**TOWN OF MOUNTAIN VILLAGE
REGULAR DESIGN REVIEW BOARD MEETING **REVISED** AGENDA
TO BE HELD IN PERSON
THURSDAY DECEMBER 2, 2021 10:00 AM
MOUNTAIN VILLAGE TOWN HALL
455 MOUNTAIN VILLAGE BLVD, MOUNTAIN VILLAGE, COLORADO**

TO: Mountain Village Design Review Board
FROM: Amy Ward, Planner
FOR: Design Review Board Public Hearing; December 2, 2021
DATE: November 17, 2021
RE: Staff Memo – Initial Architecture and Site Review (IASR) Lot 649R-17, 17 Boulders Way

AGENDA ITEM 4
PLANNING & DEVELOPMENT SERVICE
PLANNING DIVISION
455 Mountain Village Blvd.
Mountain Village, CO 81435
(970) 728-1392

SHEET # C1

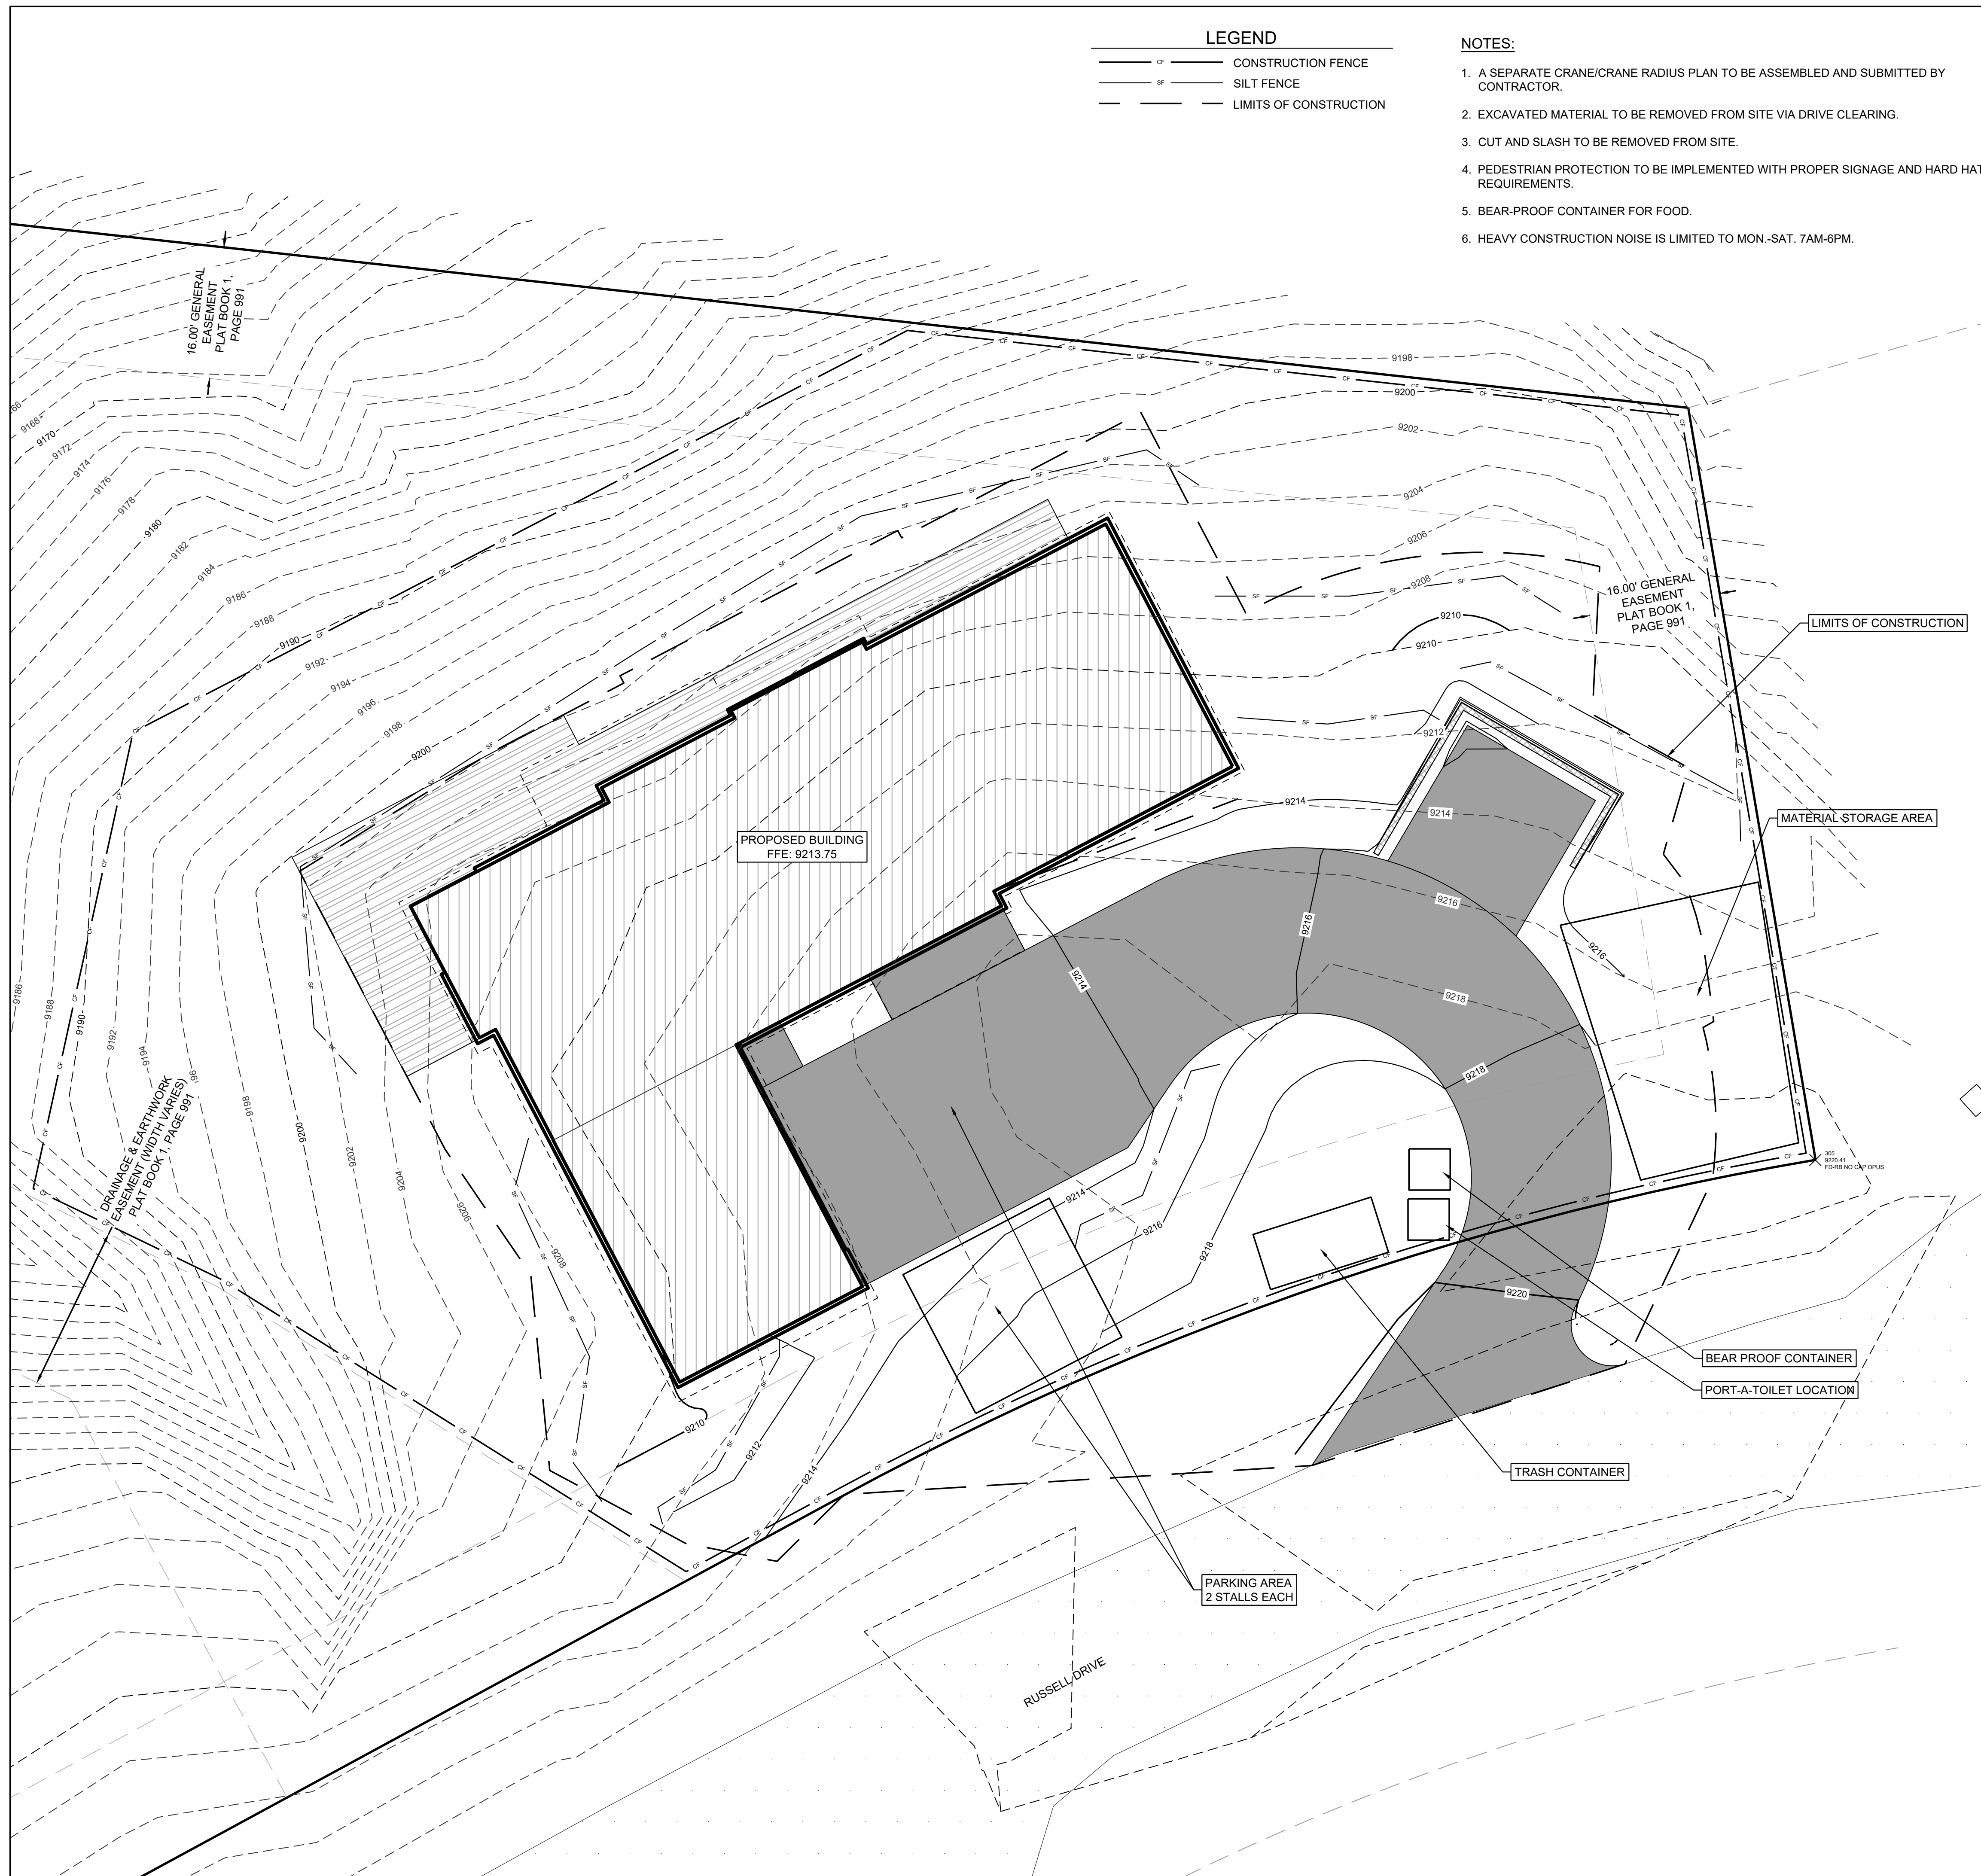
The two exterior parking spaces are missing from the Grading and Drainage Plan. The parking spaces should be shown in the civil design plans for FAR. It should be noted that otherwise the plan does demonstrate the positive drainage away from the home in accordance with CDC requirements.

- 2) Prior to FAR, the civil engineering plans should be revised to include the retaining wall and two exterior parking spaces.
- 3) Prior to FAR, the applicant shall revise the Rear Elevation to indicate what material will be used to cover the concrete foundation.

2 REAR ELEVATION
A2.01 SCALE: 1/4" = 1'-0"

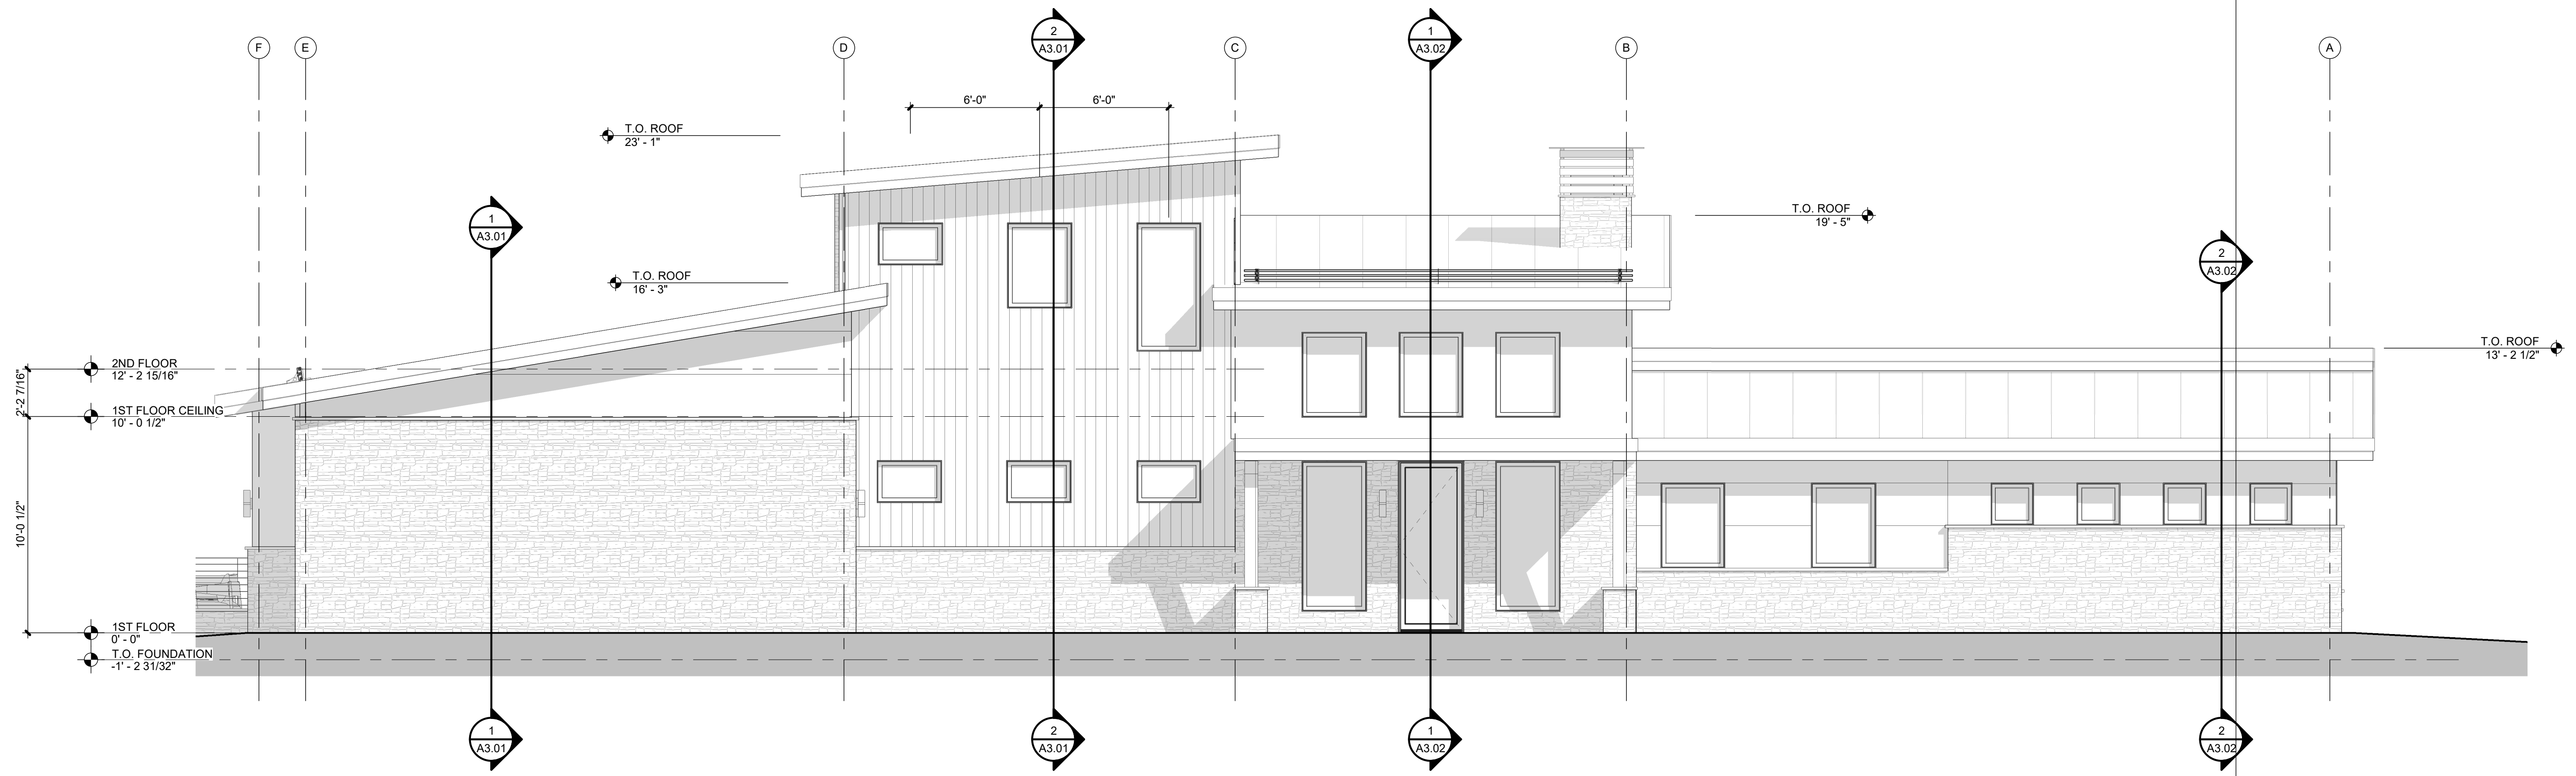
Staff's only recommendation is that the applicant take steps to break up the rear deck to create more interest, by using more than just horizontal offsets in plan view consistent with CDC Section 17.5.6.I.1.
